Stormwater Adequacy Certificate

Description: *Proposed Dwelling*

Site Address: *16 Nowill St, Condell Park NSW 2200*

Figure 1

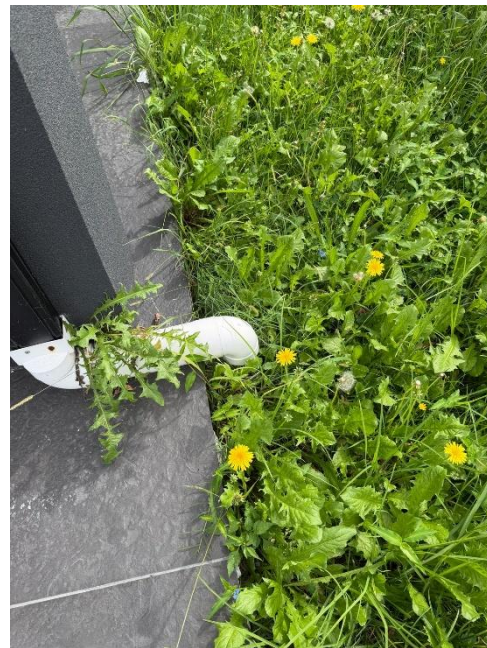
2. **Result:** Connection of DP with the main stormwater pipe is not adequate as shown in appendix A.

Solution: Connect it properly to the main existing stormwater pipe.
